Docket Number:	16-AFC-01C
Project Title:	Stanton Energy Reliability Center - Compliance
TN #:	232260
Document Title:	SERC Petition for Post-Certification Change, Construction Parking and Laydown Areas
Description:	N/A
Filer:	M. Finn
Organization:	CH2M
Submitter Role:	Applicant Consultant
Submission Date:	2/28/2020 3:10:31 PM
Docketed Date:	2/28/2020

**Subject: Stanton Energy Reliability Center (16-AFC-1C)
Petition for Post-Certification Change, Construction Parking and Laydown Areas**

Petition for Post-Certification Change

Construction Parking and Laydown Areas

Figure 1
Proposed Construction Parking and Laydown Area
 Stanton Energy Reliability Center
 Stanton, California

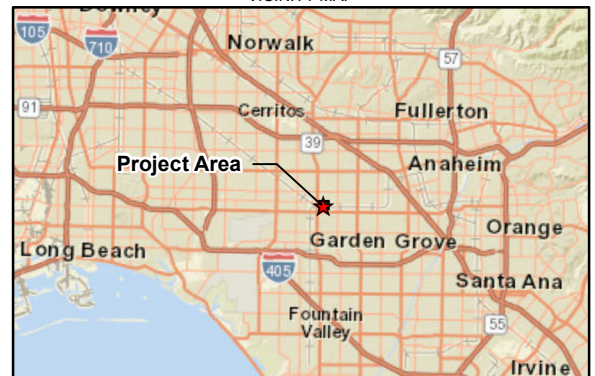
The Stanton Energy Reliability Center (SERC) (16-AFC-1C) is under construction at 10711 Dale Avenue in Stanton, Orange County, California (Figure 1). This Petition requests authority to add three newly identified construction laydown and parking areas as a change to the project description. These areas would be used by the construction contractor for worker parking, equipment laydown, and office space to replace office trailers currently on the project building site. Use of the new parking and laydown areas will be temporary and for construction only. The areas will not be used during project operation. This petition does not require changes to the Conditions of Certification.

Consistent with CEC Siting Regulations (Title 20, CCR, Section 1769 [a][1][A]), this section includes a description of the proposed project change. This Petition proposes modifying the SERC license to include additional construction laydown, parking, and staging areas that will be used temporarily for construction and not for operation. The new proposed construction laydown areas are as follows (Table 2).

Area A - consists of an approximately 0.24-acre parking area located off of Fern Avenue. This area will be used for worker parking and is currently a parking lot. There is a shrub planter at the northwestern end (Figure 1).

Area B – is a corrugated metal-clad warehouse within the same assessor's parcel as Area A. It will be used for warehousing/laydown.

Area C – is an existing industrial office building, warehouse, and parking lot. The project proposes to use approximately one half of the building, the parking lot between the building and Standustrial Street, and the open lot area between the building and the adjacent building to the east. This property will be used for offices, parking, and warehousing/laydown. A gate presently located at the southeast corner of the open lot area of the fenced property will be moved to a more central location along the fence line to enable access to the previously approved SCE laydown area located to the south of Area C.
